**Item 7.****Development Application: 19 Ralph Street, Alexandria****File No.:** D/2018/156**Summary****Date of Submission:** 21 February 2018

**Applicant:** 19 Ralph St Pty Ltd**Architect:** SJB**Developer:** Milligan Group**Owner:** E J Noble Investments Pty Ltd**Cost of Works:** \$4,680,196**Zoning:** The site is zoned B4 Mixed Use. The proposed development is defined as a mixed use development and includes one ground floor retail premises and residential accommodation comprising 18 apartments. The proposed use is permissible with consent in the B4 Mixed Use zone.**Proposal Summary:** The subject development application (DA) seeks consent for the construction of a six storey mixed use development comprising 18 residential apartments, ground floor retail tenancy and ground level car parking.

Figure 23: South (Shirley St) elevation - 22m maximum permitted height line indicated in red

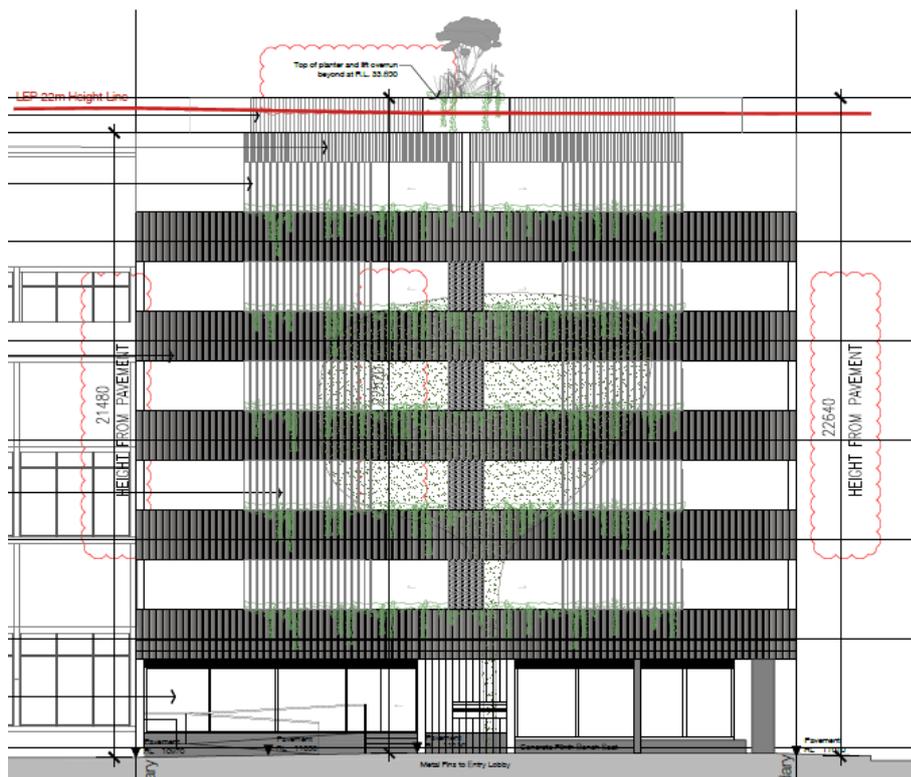
47. The site is subject to a maximum height control of 22m pursuant to Clause 4.3 of SLEP 2012. The proposed development has a maximum height of 22.64m resulting in an exceedance of the maximum permitted height by 640mm or 2.9%.
48. The areas of the building subject to the breach include the balustrades associated with the rooftop private terraces and the lift overruns, as shown in Figures 23 - 25.

**Figure 26:** Roof top plans with setbacks of balustrades from boundaries / street frontages indicated in red

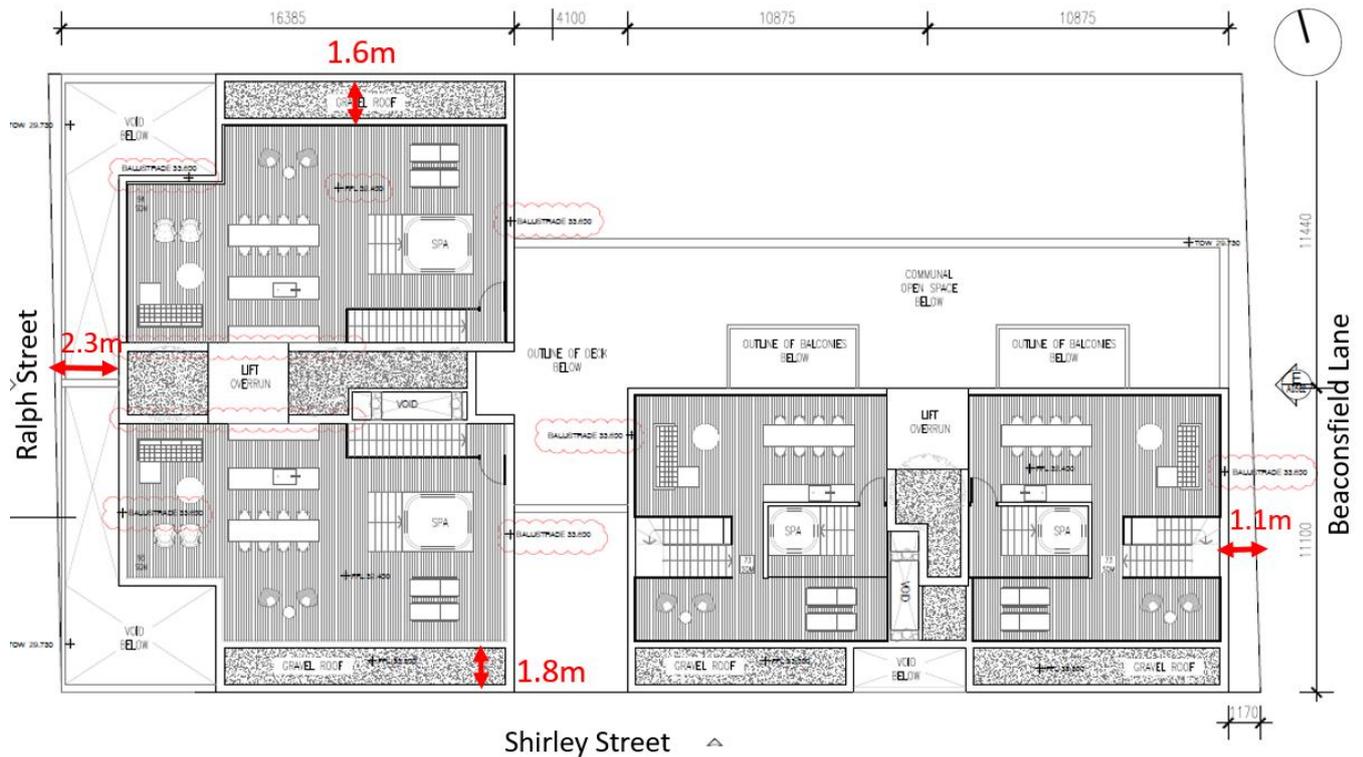
62. The areas of the building subject to the breach of height is limited to the balustrades and lift overruns. The balustrades are setback from the site's boundaries between 1.1m to 2.3m as shown in Figure 26.

63. It is considered that the balustrades and lift overruns are sufficiently setback from the street frontages so that they will not be overly perceivable from the streetscape or result in unacceptable bulk or scale of the building.

**Figure 27:** Drainage diagram for level 5 apartments and rooftop terraces

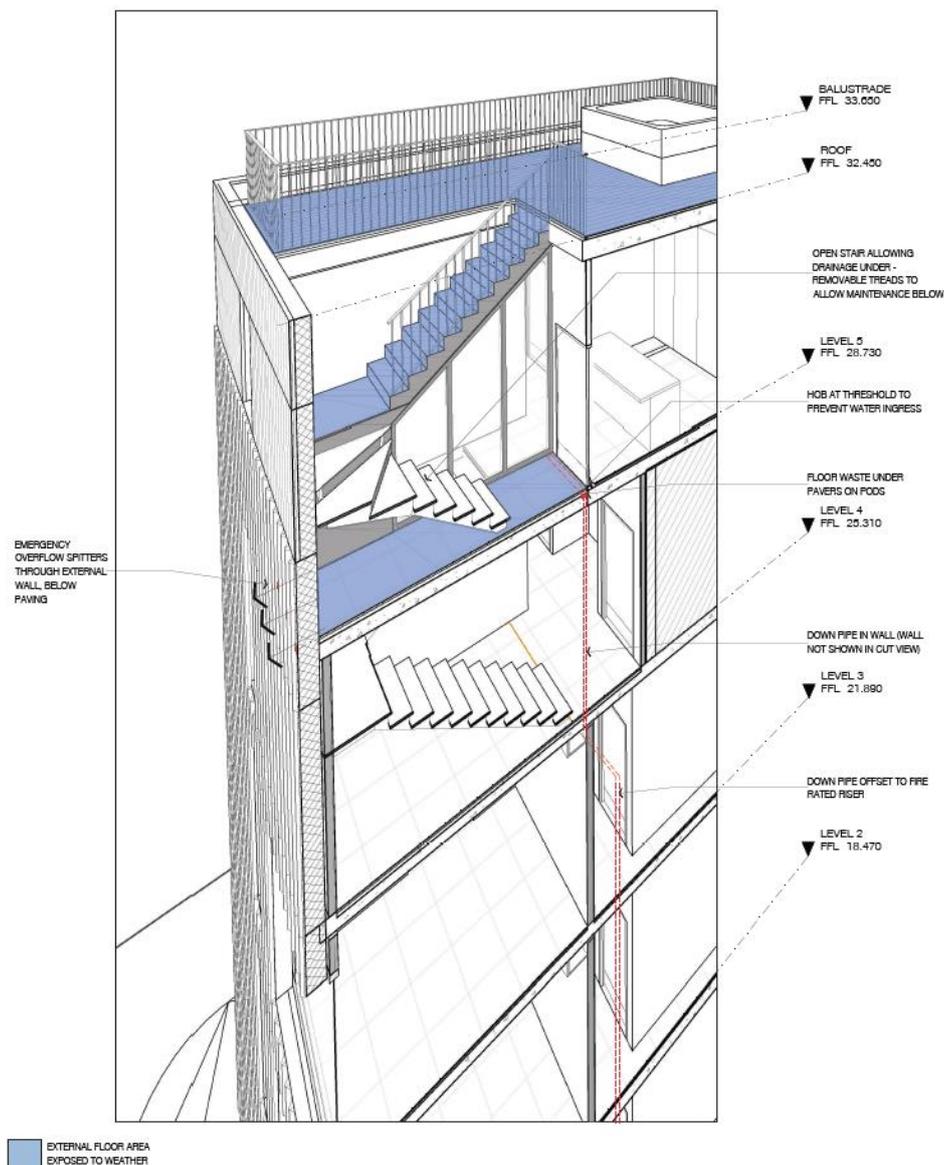
70. In the assessment of the proposed building height, Council officers raised concern with likelihood that additional rooftop structures may be required to address privacy between the terraces and weather protection of the stairs leading up from the interior of the apartments to the private roof terraces. Such structures would be sited above the proposed maximum height shown on the plans and as detailed in the Clause 4.6 written request.

71. The applicant provided additional information demonstrating how stormwater will be managed without the need for a canopy structure (or the like) above the open stairs (see Figure 27).

Figure 28: Level 2

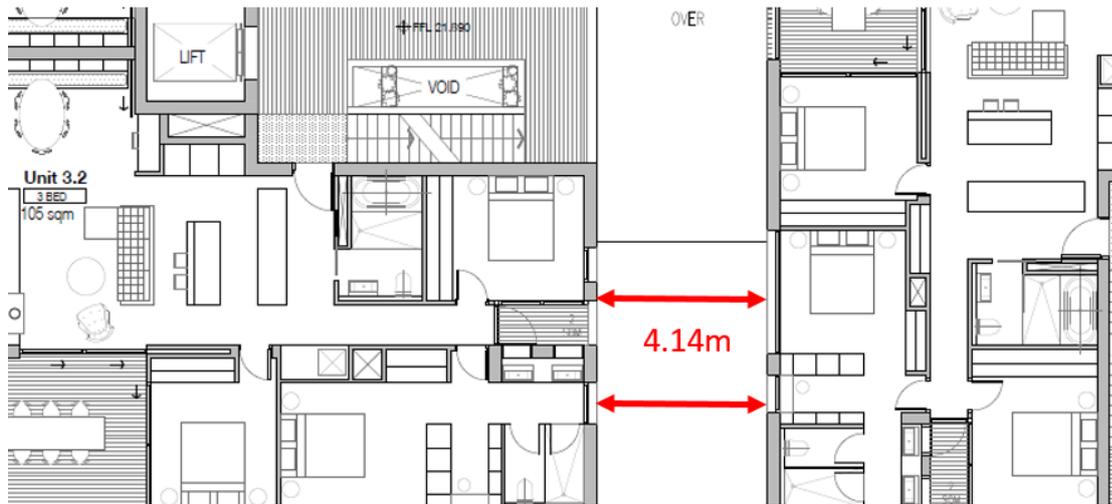
75. Ideally when assessing the building separation from adjoining development or future development, the separation distance is shared equally between adjoining development sites. Essentially, the required distance is halved and measured to the common shared boundary. Using this rationale the proposed development has been designed to comply with these building separation distances.
76. However, the approved residential flat building at 17 Ralph Street (D/2016/198) has non-compliant setbacks in accordance with the ADG and consequently 'borrows' amenity from the subject site. The building separation distances between the two sites is shown in Figure 28:

77. Notwithstanding, the proposed development is not considered to result in unreasonable privacy impacts to the approved development at 17 Ralph Street. This is due to the primary outlook of the rear wing apartments being north. There is an open communal corridor running along the south side of these apartments including their living room windows. The open corridor includes louvres which provides additional privacy between the two sites.
78. Given the above, the siting of the proposed development is considered to provide adequate privacy for future residents of the subject site and of 17 Ralph Street, and the non-compliance is supported in this instance.

**Figure 29:** Typical levels 2 and 3 - visual privacy impact between bedroom windows and between bathroom and walk-in-robe windows.

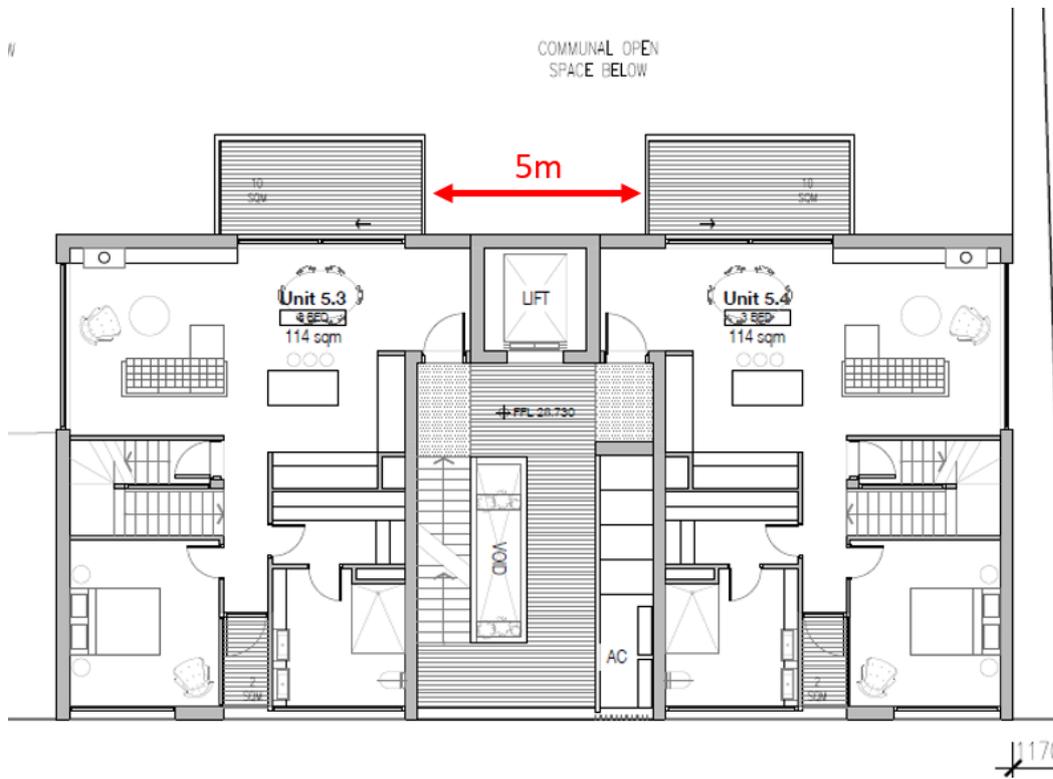
79. A number of habitable windows and balconies result in visual privacy impacts between different apartments which does not comply with Objective 3F of the ADG. These components of the building where concern is raised with privacy are identified in Figures 29 - 32:

80. Conditions of consent are recommended to address these visual privacy issues through provision of privacy screens, raised sill heights and/or obscured glazing where appropriate.
